SECTION 8: INTRODUCTION

Scenic Impact Analysis Review for Eastside Transmission Project

Dean Apostol

March 10 2019

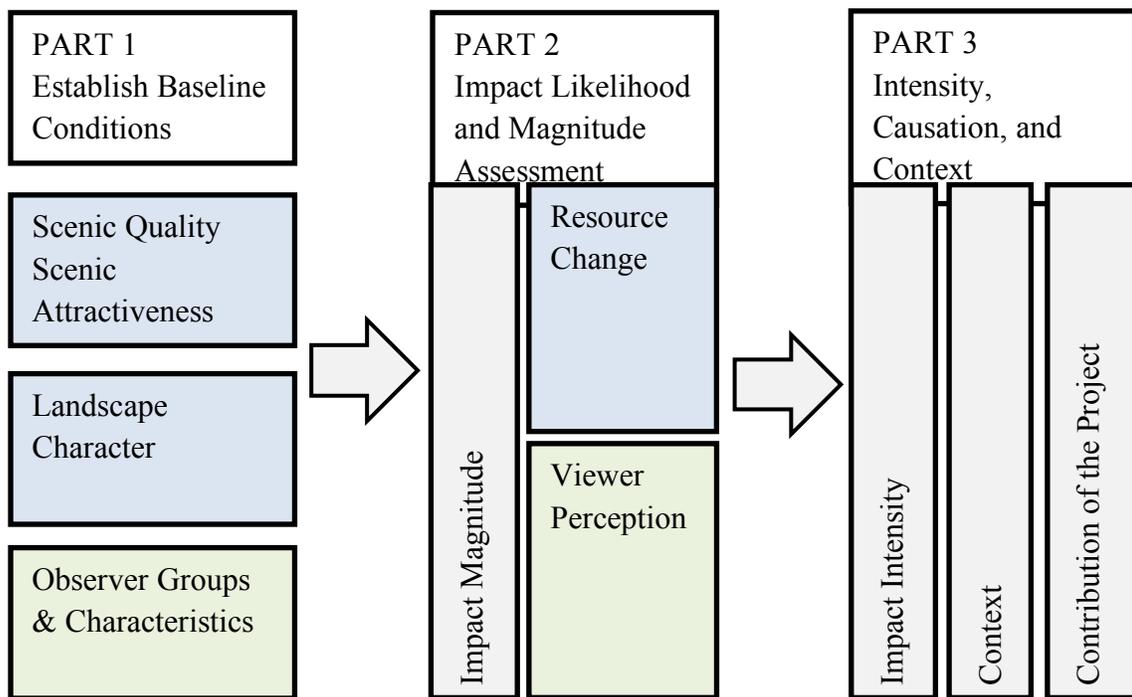
In my own experience, which includes over 30 years of practicing Visual Impact Assessment, a rough formula for determining level of impact is:

High viewer sensitivity + high negative visual contrast (from project) + large geographic extent + long duration (of impact) = significant impact.

I asked Robert Ribe, Professor of Landscape Architecture at University of Oregon, to review this formula and he concurred and added that this represents a "best practices" approach. Additionally, the methodology for the recently completed scenic impact analysis for the *Boardman to Hemmingway Transmission line* in Oregon included the following flowchart to illustrate the procedure used.³³):
